TOWN OF MEDWAY
Planning & Economic Development Board
155 Village Street
Medway, Massachusetts 02053

May 29, 2019

MINOR MODIFICATION
ADULT RETIREMENT COMMUNITY PLANNED UNIT DEVELOPMENT (ARCPUD)
SPECIAL PERMIT PLAN
Continuing Care Management, LLC
The Willows at Medway and Whitney Place
259, 261, 261R and 263 Village Street

PROJECT NO. 1507
SHEET NO. L1.02

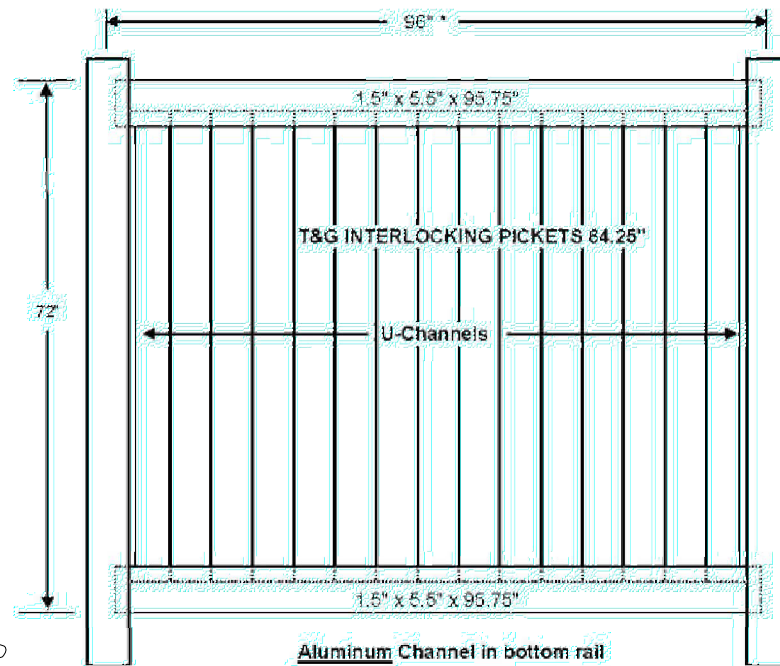
The proposed change entails not removing the existing vegetation and stone wall along the eastern border of the property east of Waterside Run. This modification is a result of fully evaluating the buffer area after performing considerable site work and learning of concerns raised by the easterly abutting neighbors about the extent and impact of further clearance. Instead, Mr. Robinson has proposed to retain the existing landscape material and dead vegetation in the buffer area. Approximately 95% of the originally planned and approved new infill landscaping will be installed and the permanent privacy fencing as originally proposed will also be installed as previously approved. This proposal is a result of discussions held during a site visit on April 30th by PEDB members Andy Rodenhiser and Tom Gay and the developer's communication with abutter Tim Choate of 7 Iroquois Street on behalf of the abutting neighbors.

The Planning and Economic Development Board reviewed the revised landscape plan - Sheets L1.02, L1.04 and L1.06 dated May 8, 2019. See attached. The Board voted to approve this minor modification to the ARCPUD plan as proposed and described herein subject to the following conditions:

- The changes shall be shown on the as-built plans to be provided at the conclusion of the project.
- The infill landscaping work and the installation of the permanent privacy fence shall be completed by November 30, 2019.
